## **AMENDED APPLICATION CLASS 1**

Planning law – application to modify development consent granted by the Court (s 4.55(8)  
*Environmental Planning and Assessment Act 1979*)

Application to modify the development consent to DA55/19 for the land at 5 Bay View Street, Lavender Bay granted by the Land and Environment Court on 3 September 2020 by *Camuglia v North Sydney Council* [2020] NSWLEC 1406 (proceedings 2019/268493) which approved the demolition of existing structures and construction of a new residential flat building containing three units, a new garage structure and associated works (**the approved development consent**).

The Application seeks the ~~removal of the step in the roof and the~~ deletion of condition A2 of the approved development consent which requires the roof ridge height and surrounding parapet for the structures at Bay View Street level, comprising the car lift, visitor's car space and pedestrian entry lift and stairwell, be reduced to RL 22.00.

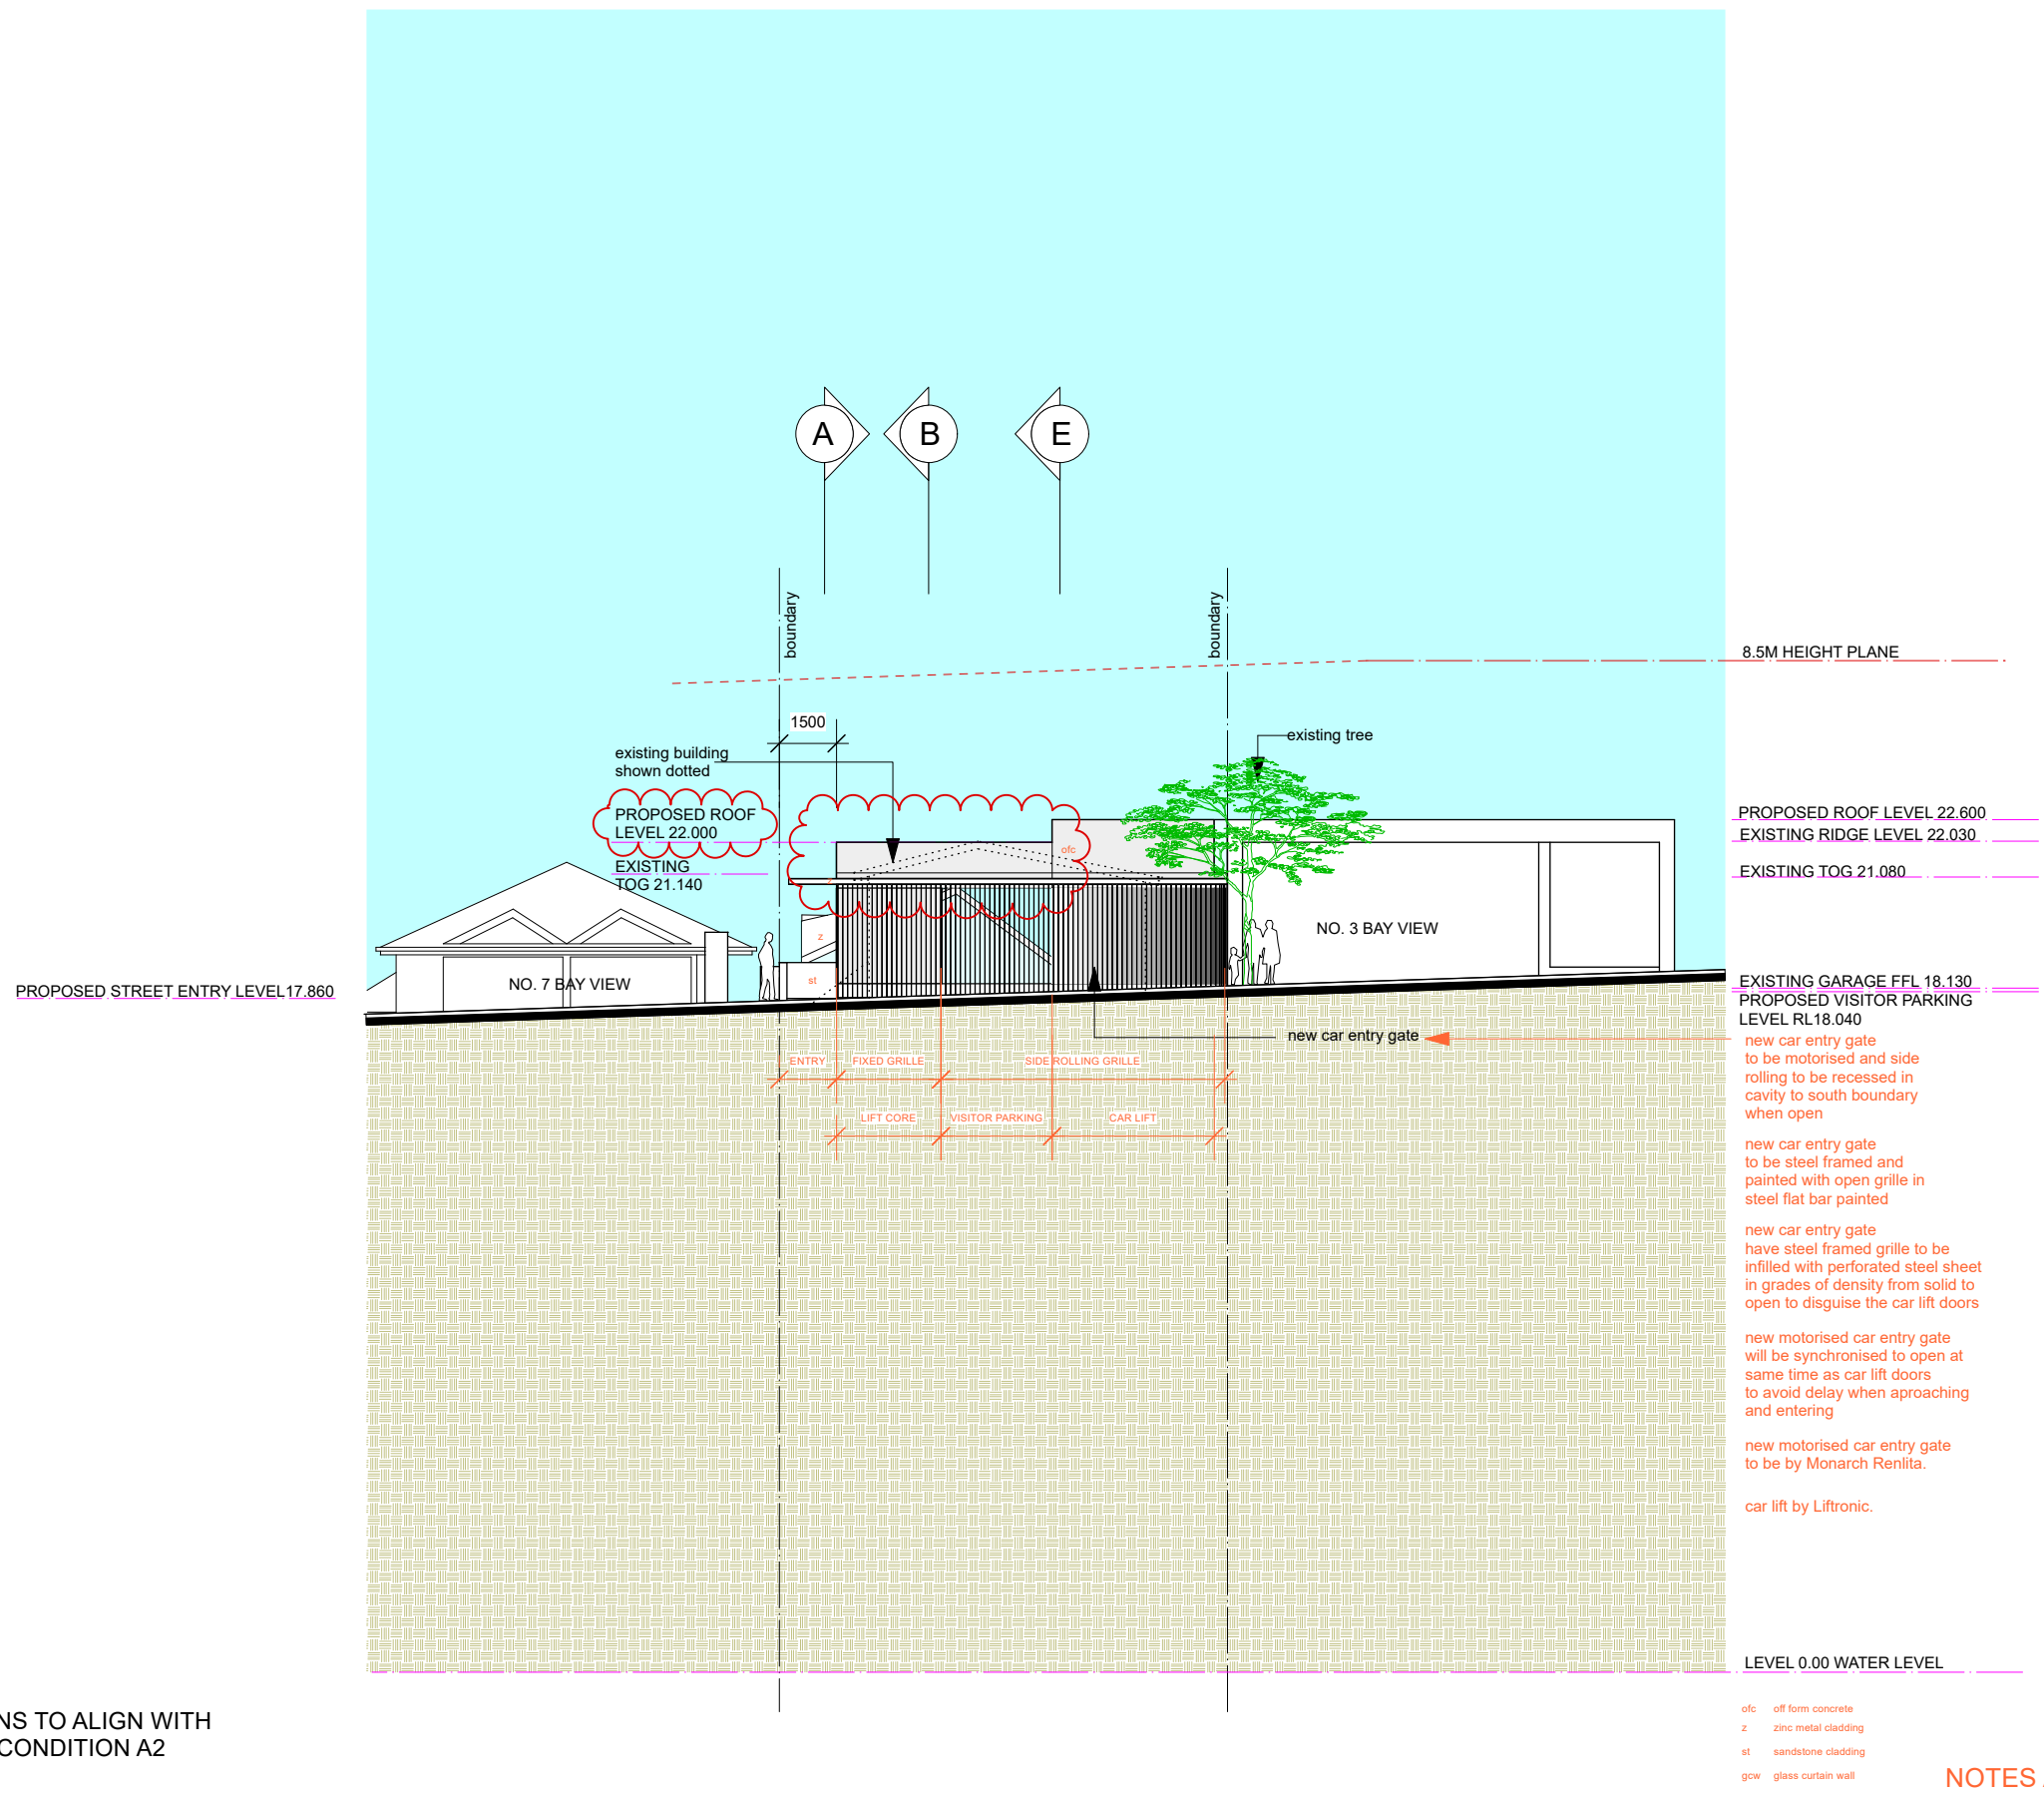
INDICATES REVISIONS TO ALIGN WITH DA55/19 APPROVAL CONDITION A2

**SOUTH-EAST  
ELEVATION**

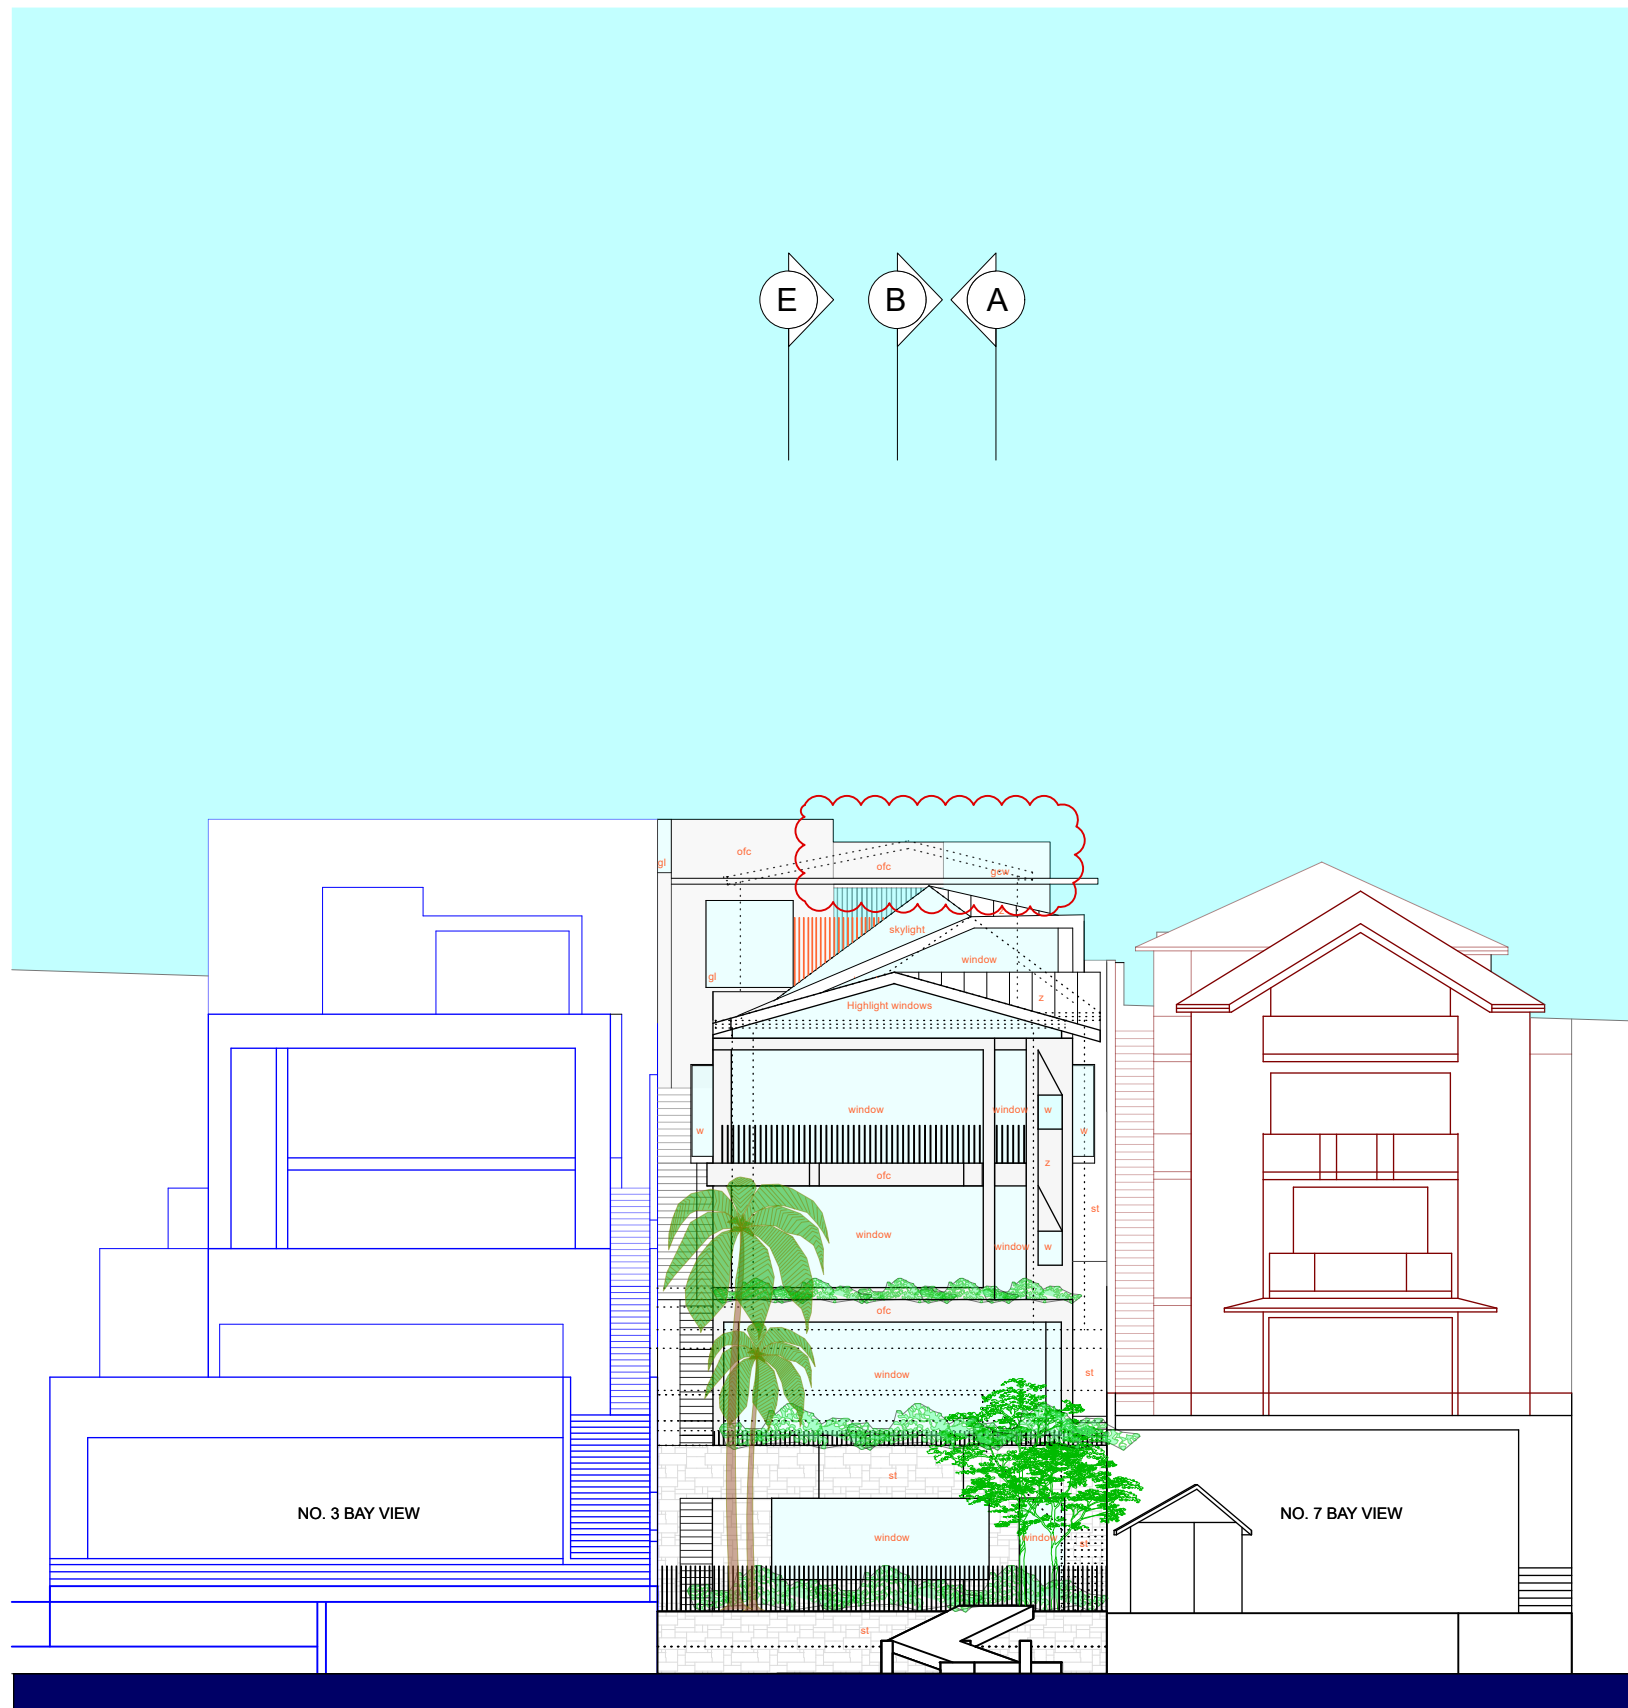
INDICATES REVISIONS TO ALIGN WITH  
DA55/19 APPROVAL CONDITION A2

**SOUTH-WEST  
 ELEVATION**

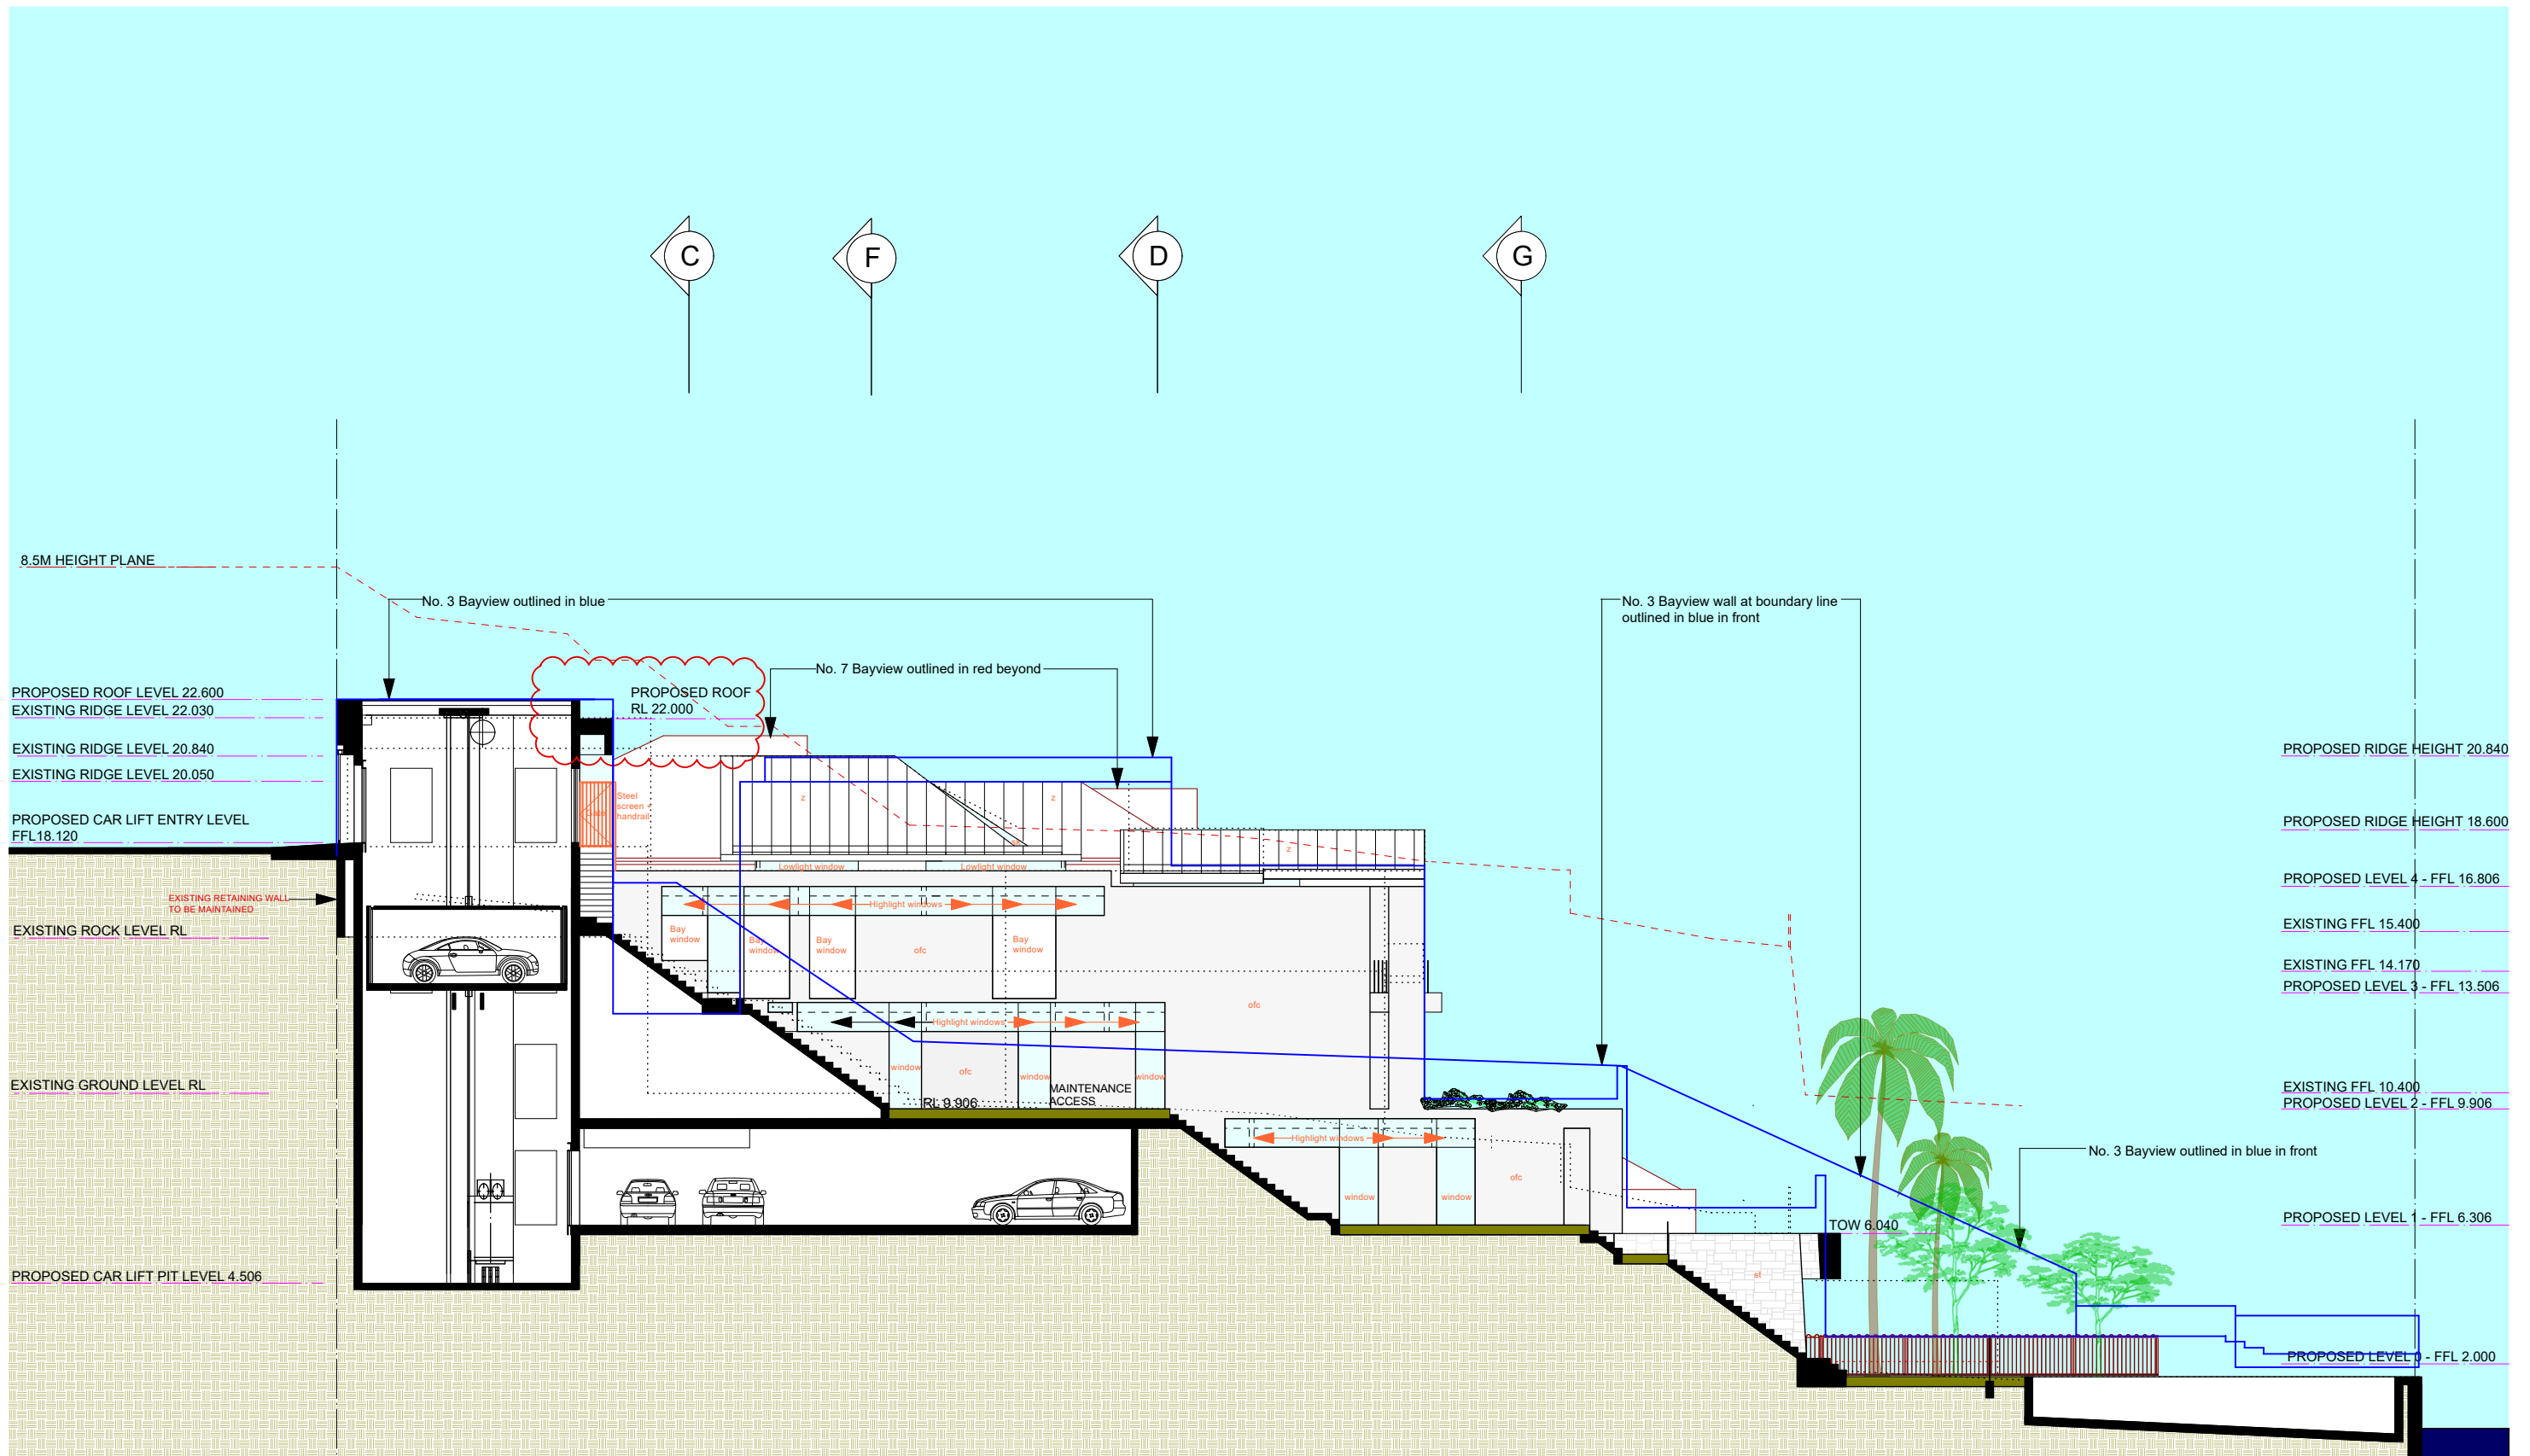
INDICATES REVISIONS TO ALIGN WITH DA55/19 APPROVAL CONDITION A2
